Lee's Summit Logistics
Building A Lot 1
NW Corner of NE Tudor Rd. & Main St.
Lee's Summit, MO 64086

ISSUE TYPE
FOR REVIEW AND APPROVAL

- 5719 Lawton Loop East Drive, SUITE 212, INDIANAPOLIS, IN 46216
O : 317.288.0681 F : 317.288.0753
- ☒ Reviewed as Submitted
☐ Reviewed as Noted
☐ Resubmit as Noted
☐ Disapproved, Resubmit
☐ No Action Taken

TILT-UP PANEL PLAN T1.1

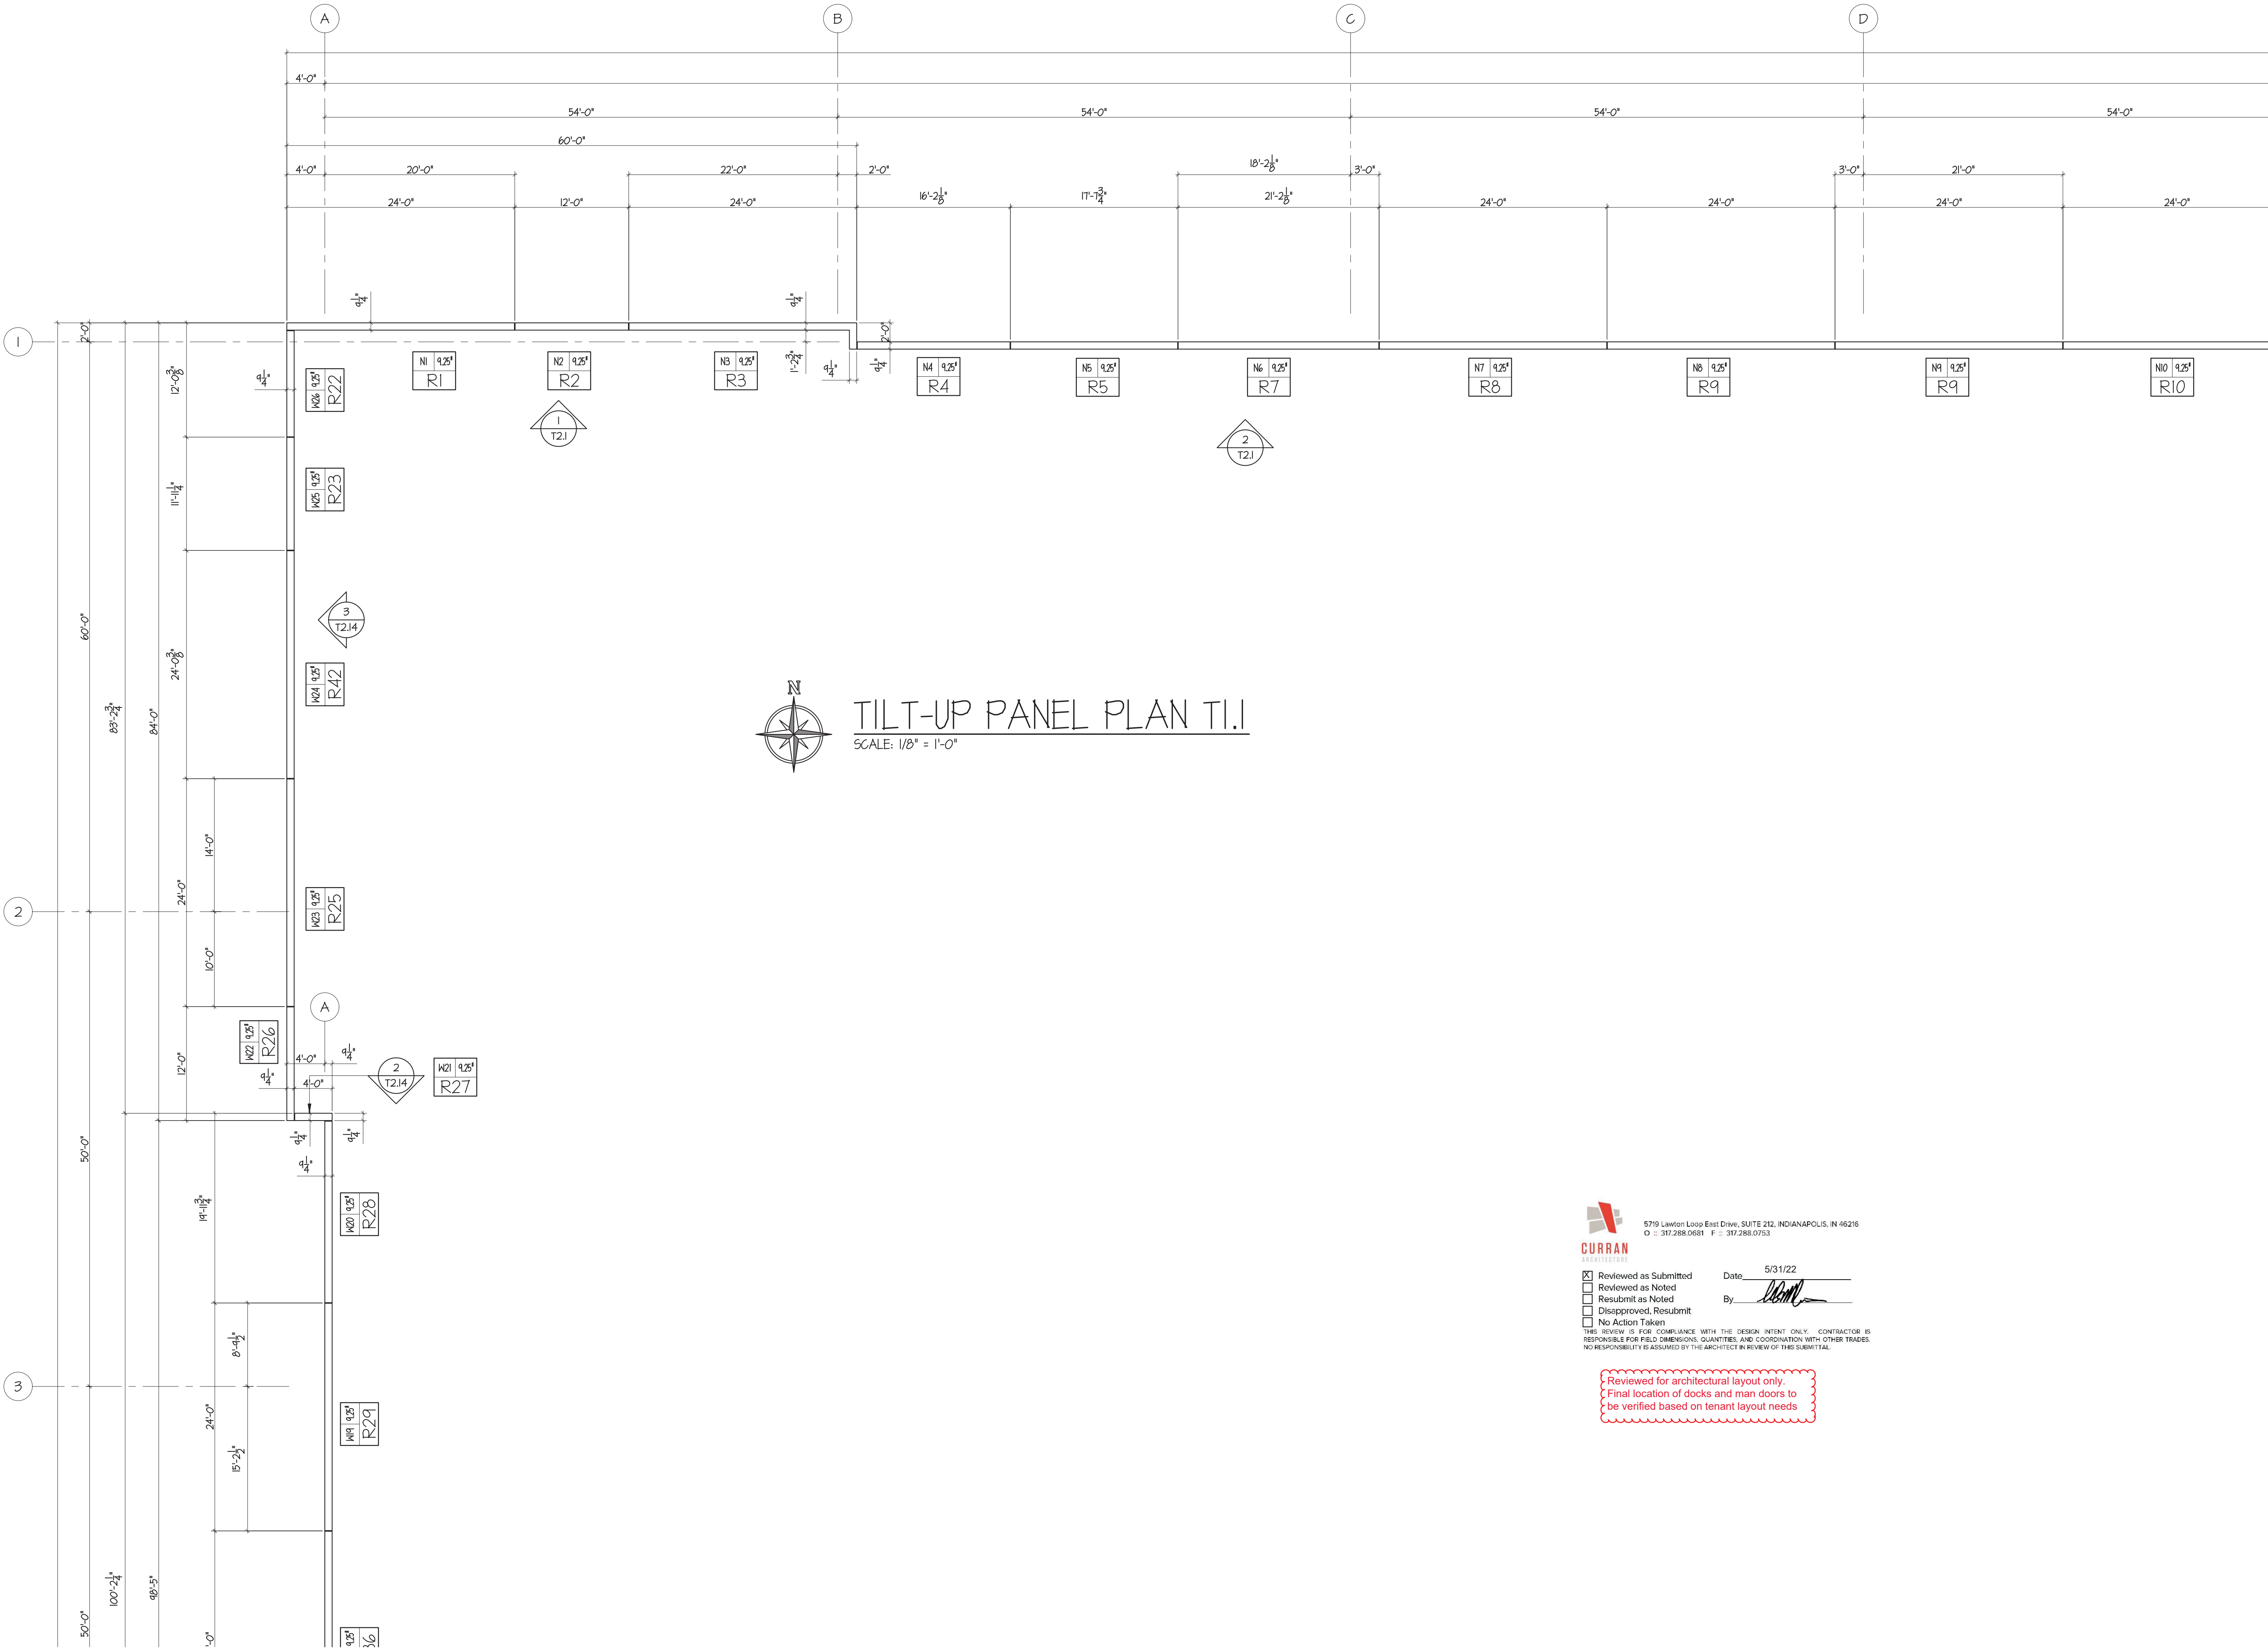
Reviewed for architectural layout only.
Final location of docks and man doors to
be verified based on tenant layout needs
